### Harrisville City Planning Commission Harrisville City Offices Wednesday, November 9, 2022 – 7:00 p.m.

## MEMORANDUM

RE: **BEN LOMOND PHASE 2-D SUBDIVISION**  
**Preliminary Plat Submittal**

Our office has completed a review of the preliminary plat and improvement plans for the Harrisville Fields Subdivision located in between North Harrisville Road and 400 North at approximately 375 West. The development is a cluster development and includes 51 single family homes and a large open space area. The Developer is proposing to break up the development into two phases but is requesting preliminary approval of the overall site at this time. If preliminary approval of the entire subdivision is granted, then they will come back to receive final approval for each individual phase.

**1990 NORTH PLAN VIEW**  
CENTERLINE OMITTED FOR CLARITY

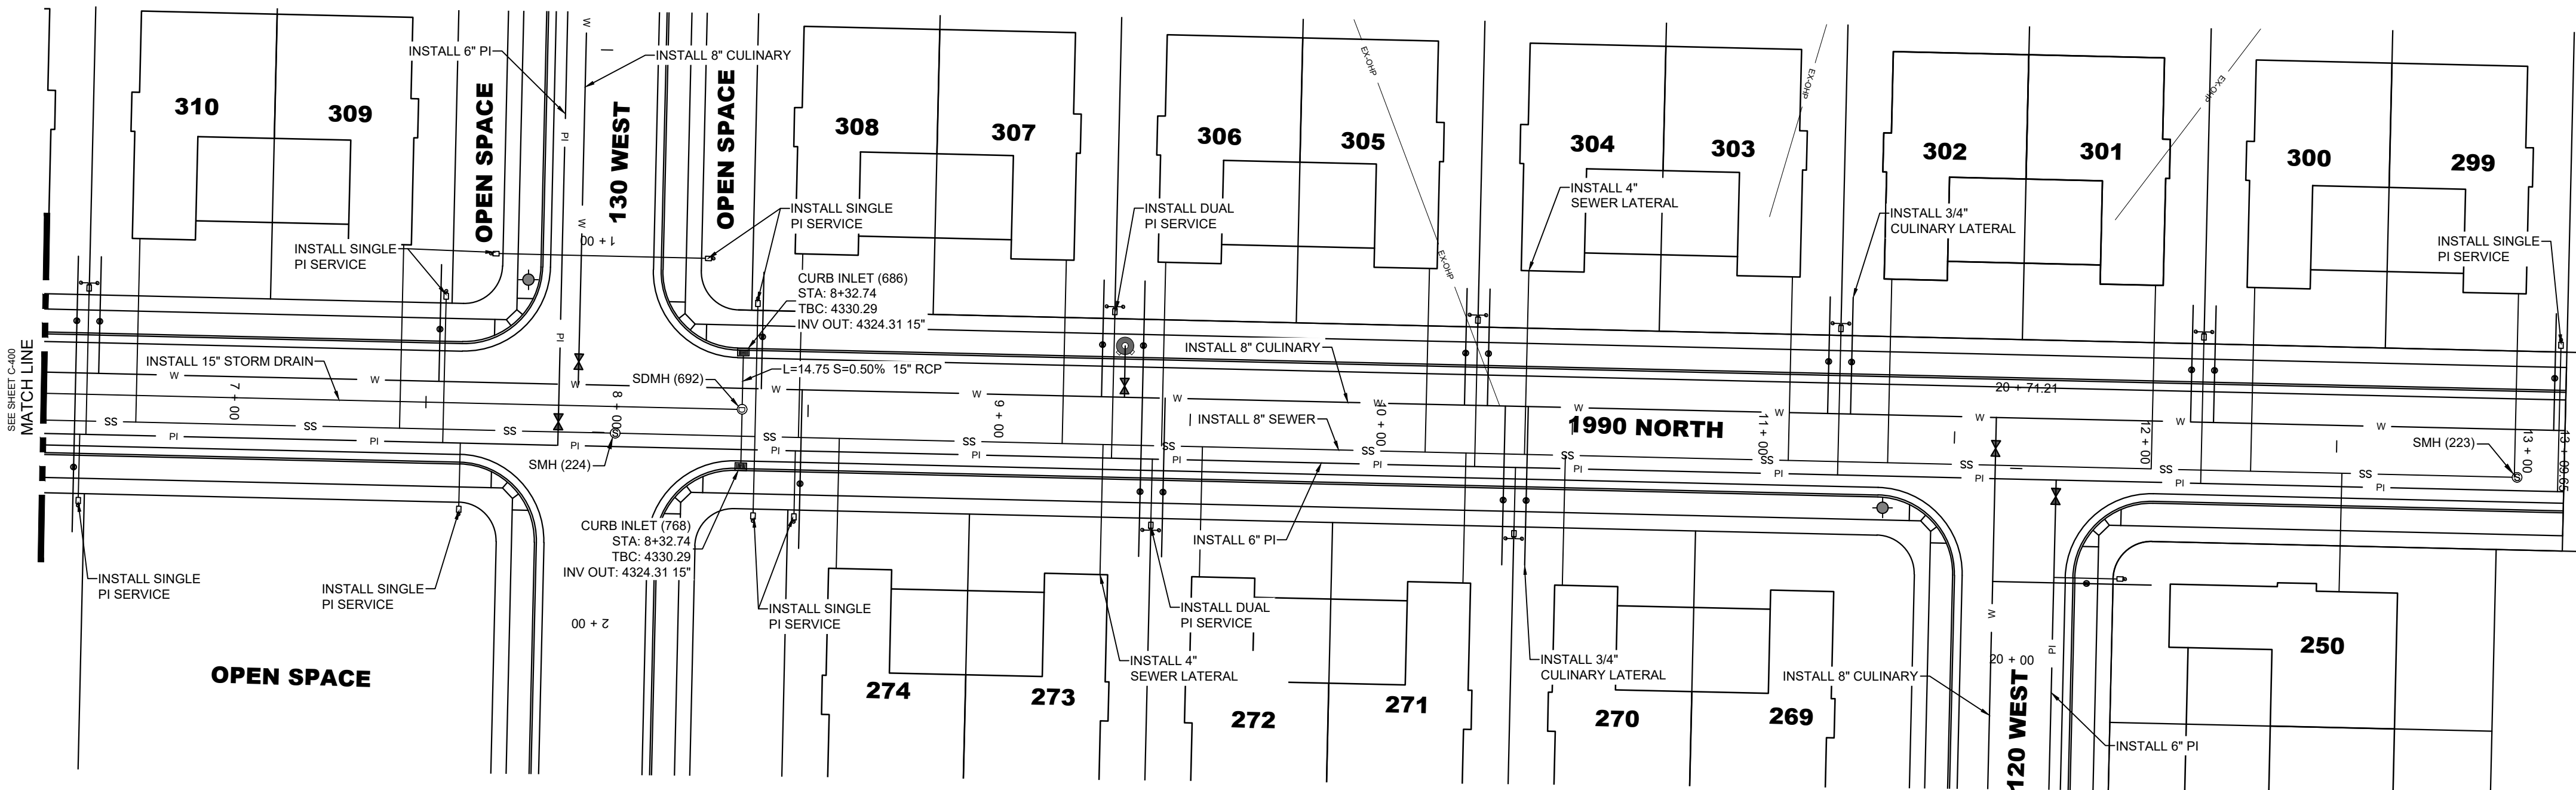
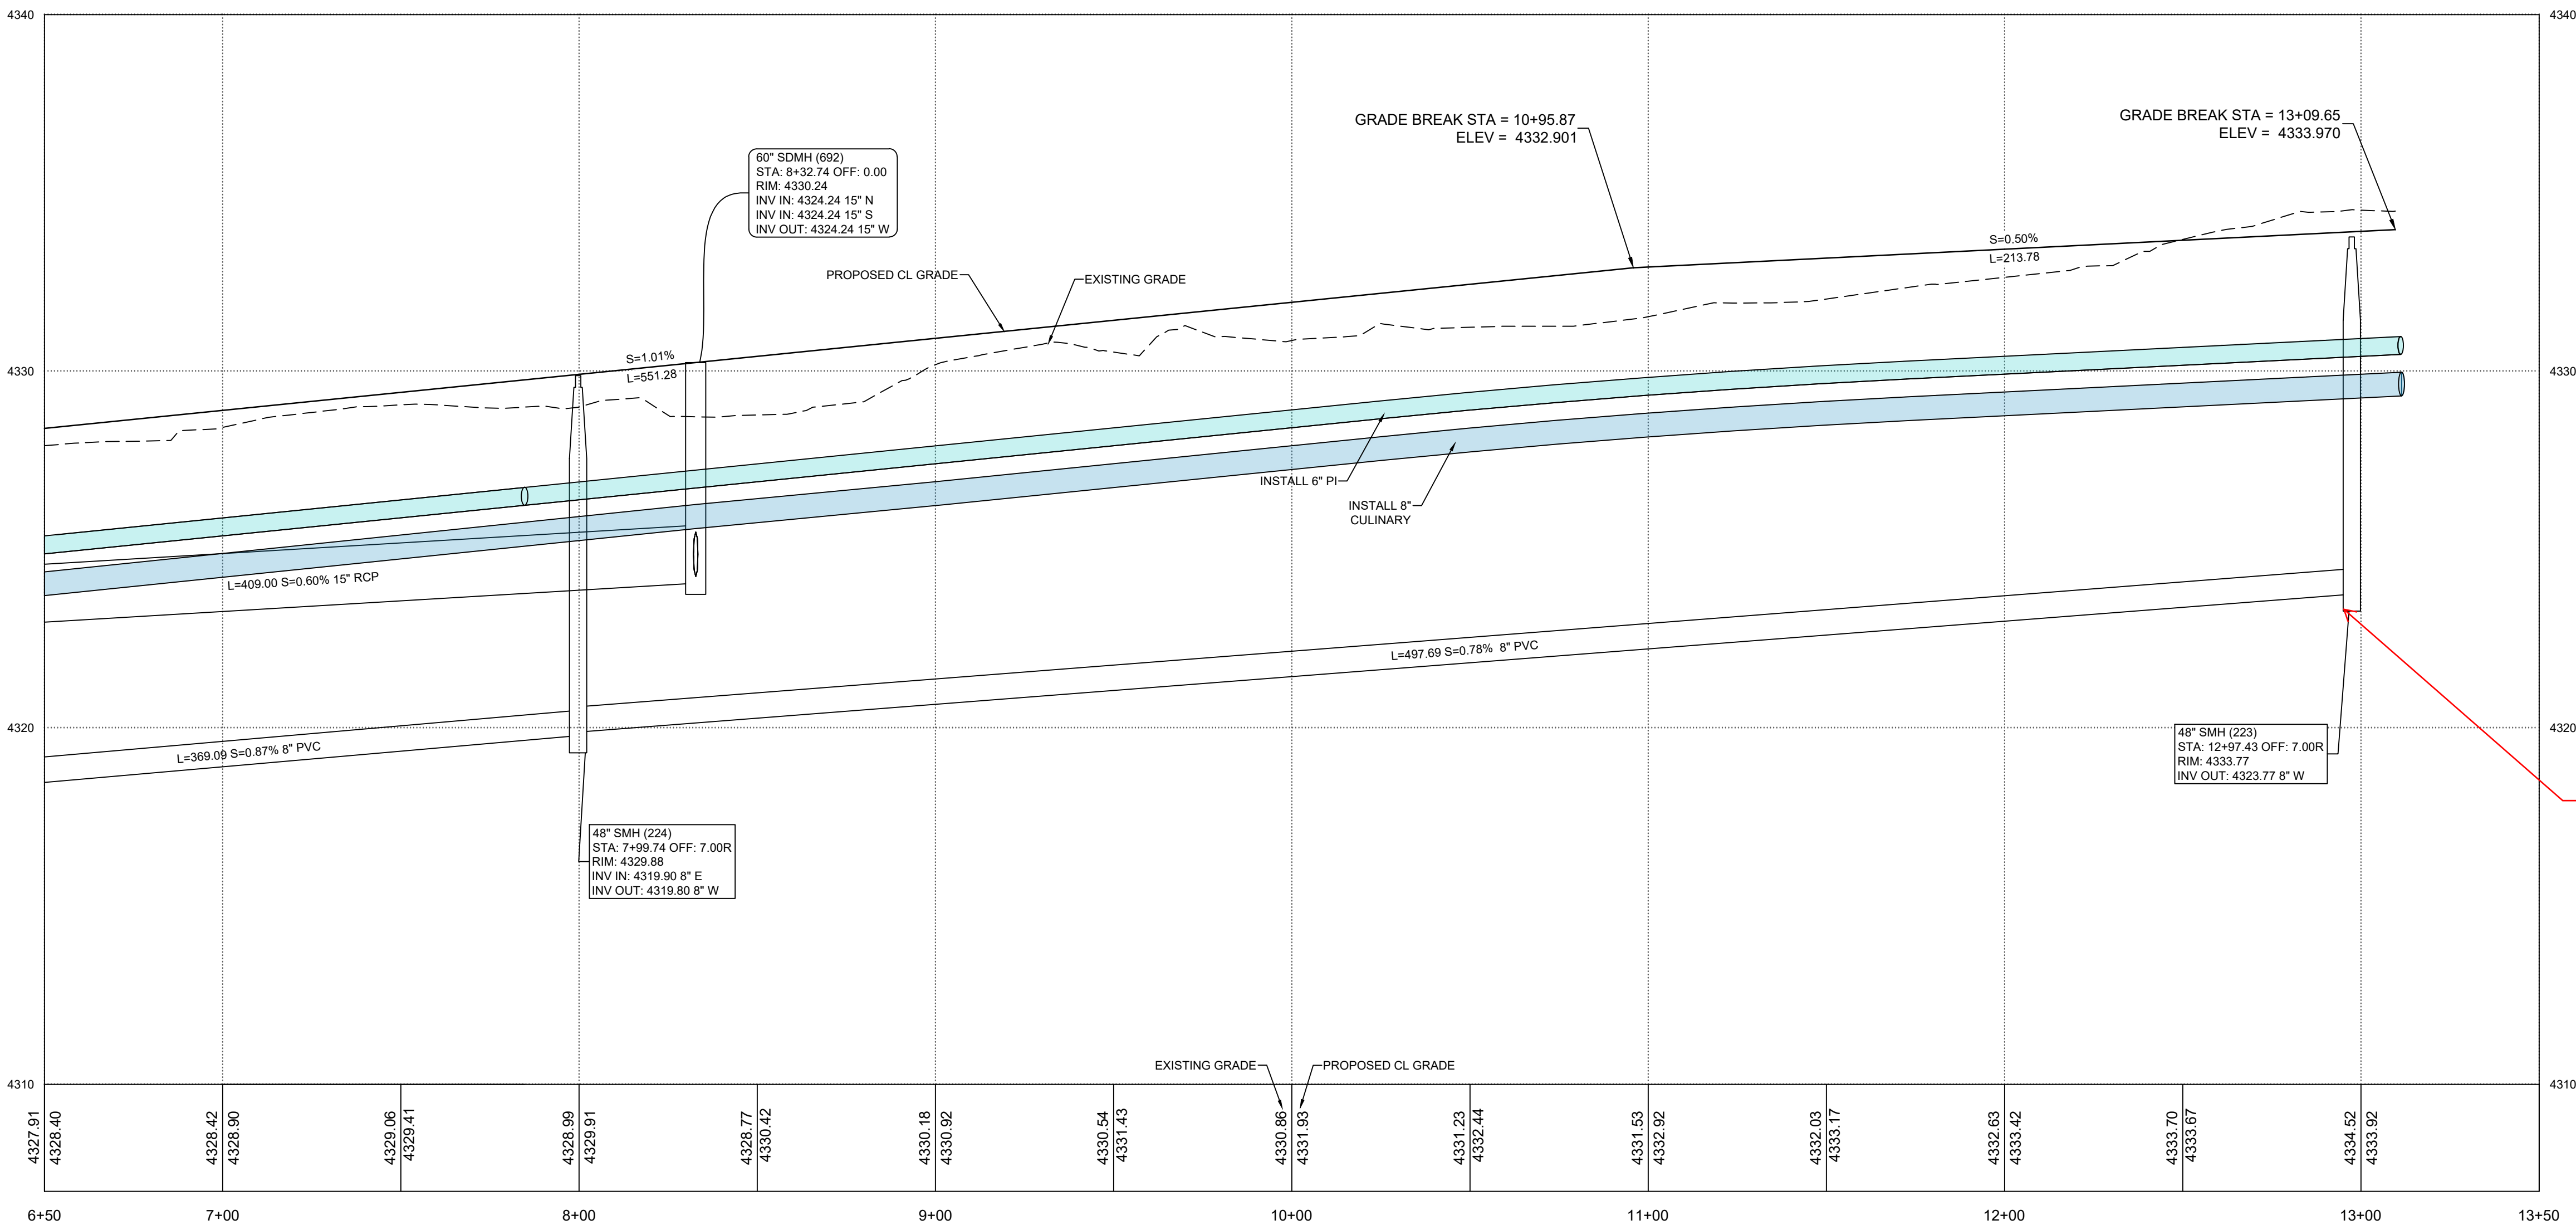
IS THERE ANY REASON TO HAVE THIS SEWER 10' DEEP? WHY NOT PLACE IT AT 6'-8' DEEP TO MINIMIZE THE AMOUNT OF EXCAVATION AND MAKE IT EASIER TO MAINTAIN IN THE FUTURE?

OVERALL SITE PLAN

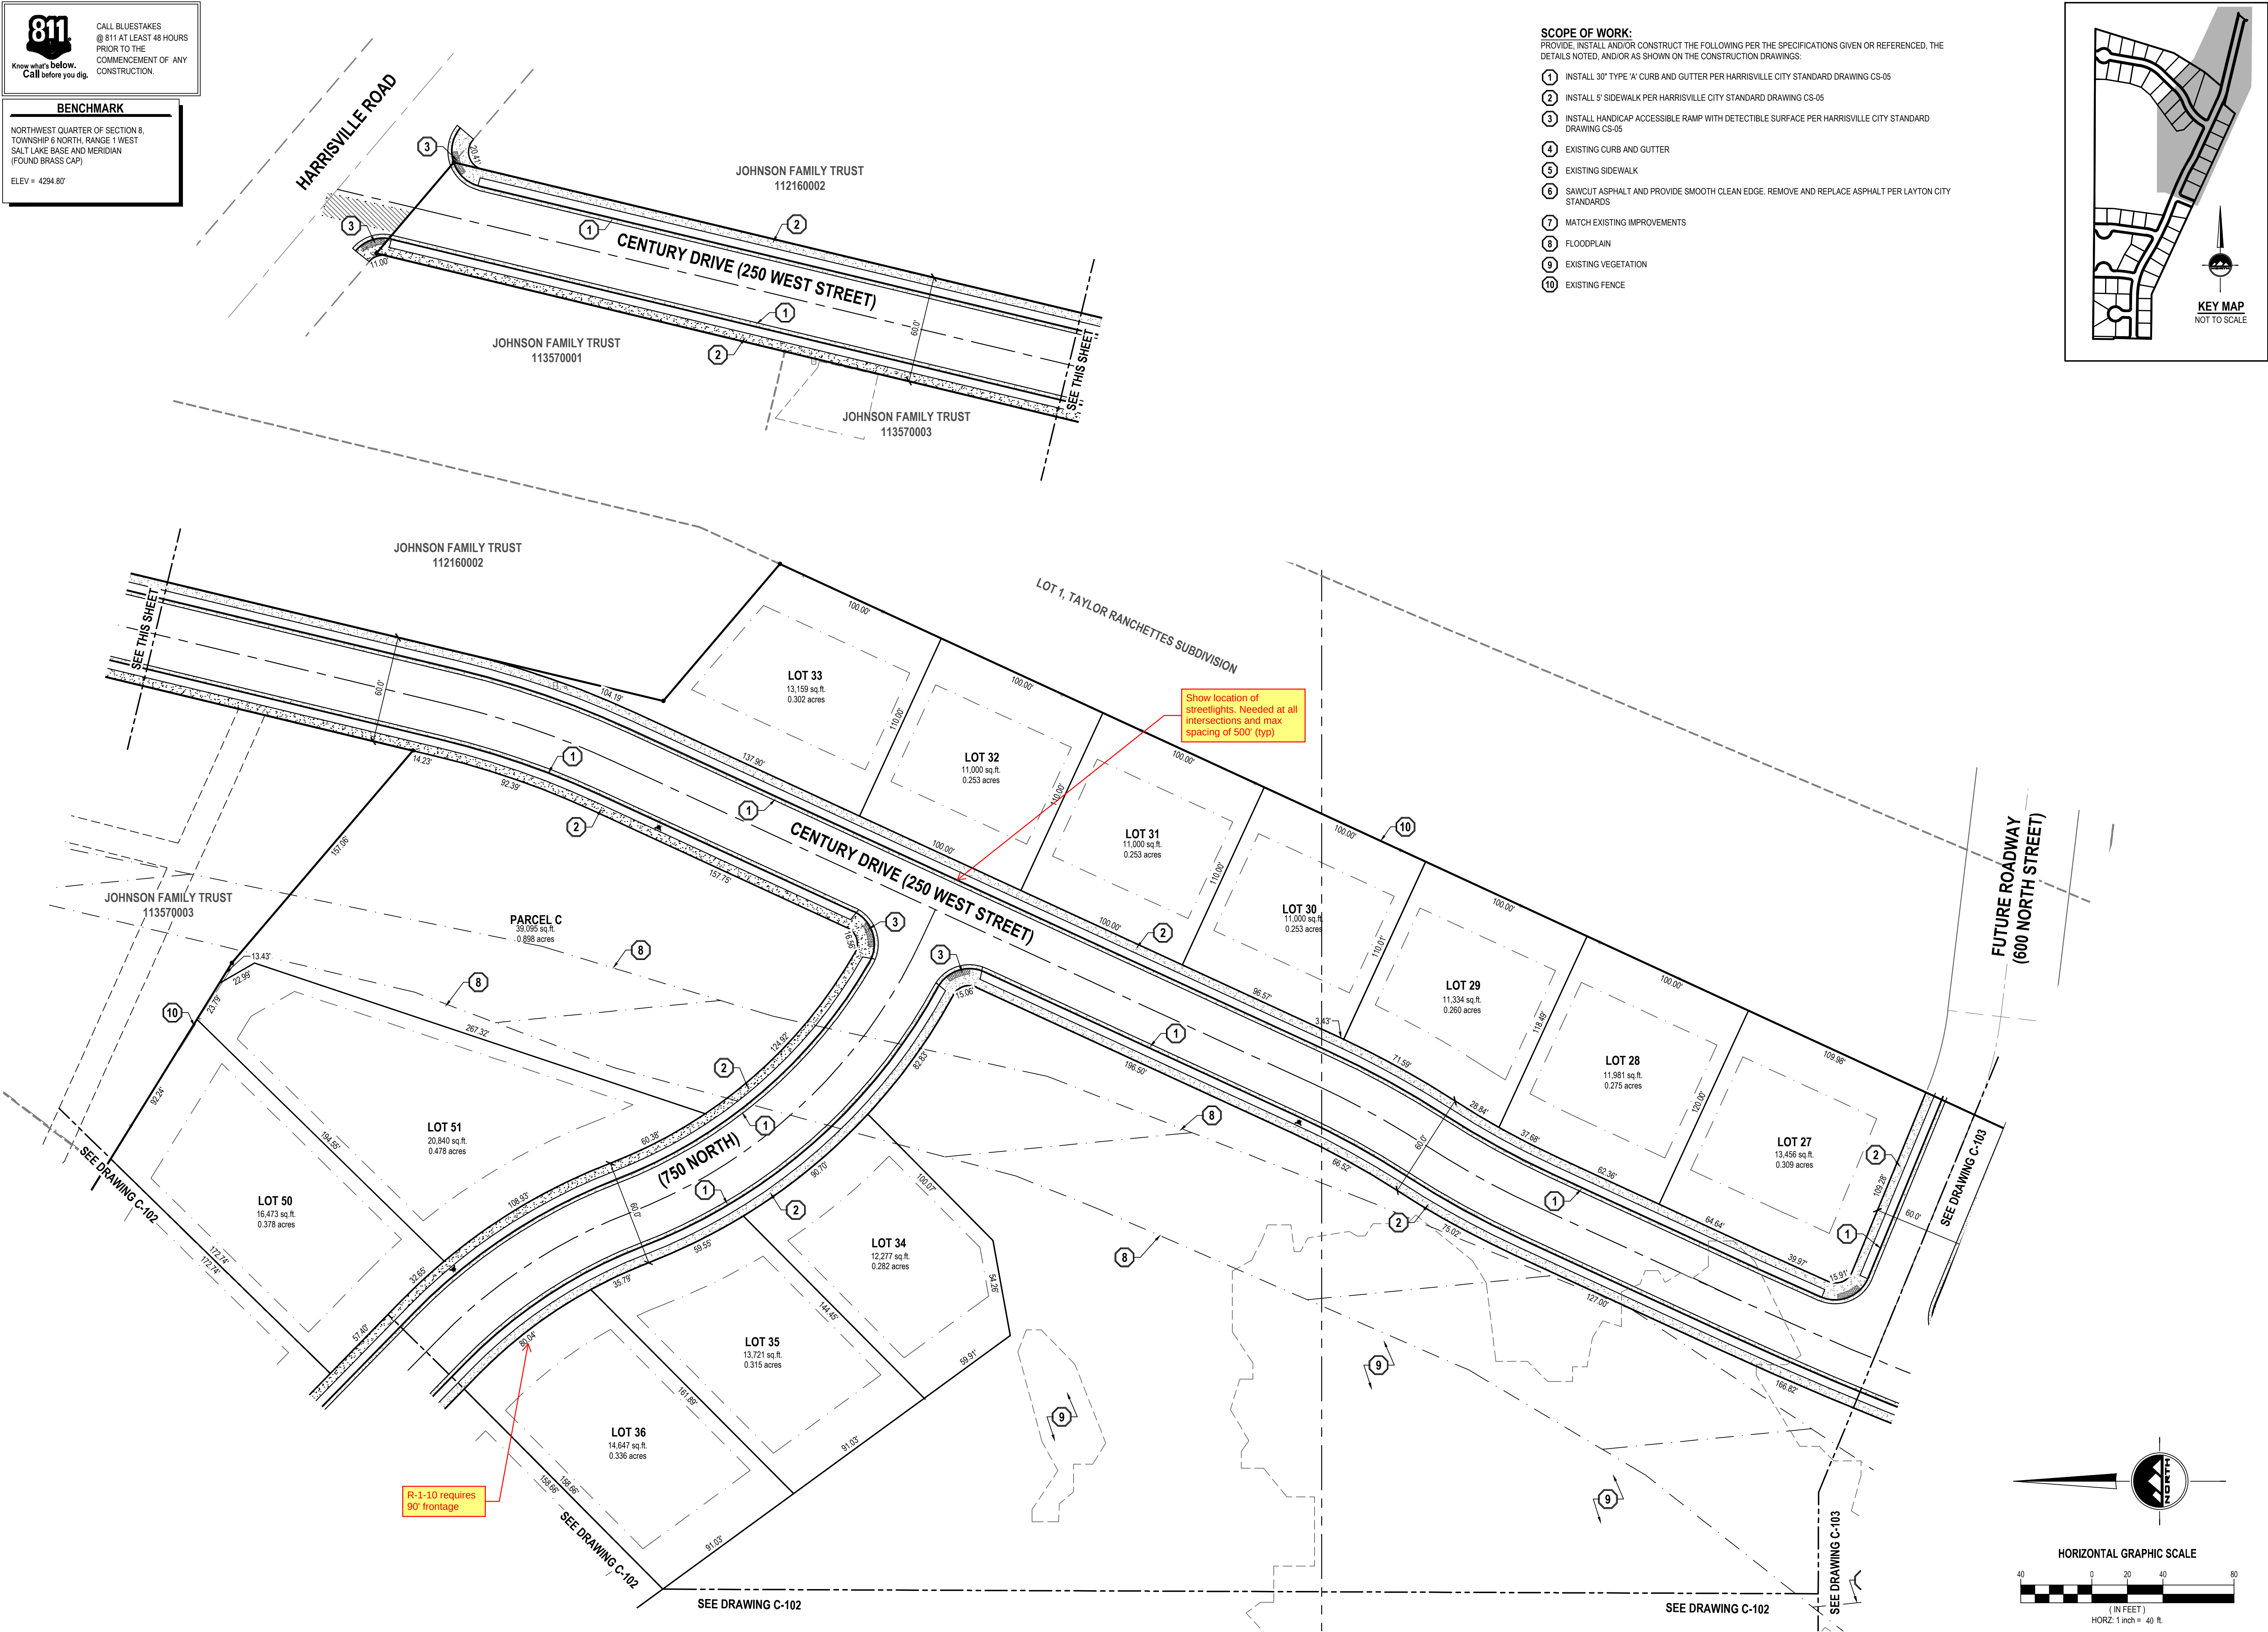
Is a combined pond being proposed? Some plans show a detention basin in Parcel B and a secondary pond in the open space.

What shares does the property have? From 4-Mile or Dixon Creek? Provide more information.

PROVIDE A SUBDIVISION DEDICATION PLAT WITH DESCRIPTIONS, ALL MEASUREMENTS AND CURVE INFORMATION, EASEMENTS, ADDRESSES, SIGNATURE BLOCKS, ETC. THIS PLAT MUST BE REVIEWED BY OUR OFFICE AND BY THE WEBER COUNTY SURVEYOR.

IF THE DEVELOPMENT IS TO BE SPLIT INTO DIFFERENT PHASES - SHOW THE DIFFERENT PHASES ON THIS OVERALL PLAN

Show all drainage easements. Existing Hart Subdivision shows easements for Dixon Creek and Four-Mile Creek. Are those being maintained or moved? (TYP)

Show location of existing buildings and pond. Are they to be removed?

Provide curve information and ensure that it meets City Standard for horizontal curves (TYP)

Obtain approval from Ogden City for street connection

Is the total open space area listed anywhere? To verify cluster development requirements

Are any improvements being proposed in the open space? Or to remain as-is? The City's park and trails master plan shows a potential nature park and walking paths in this area
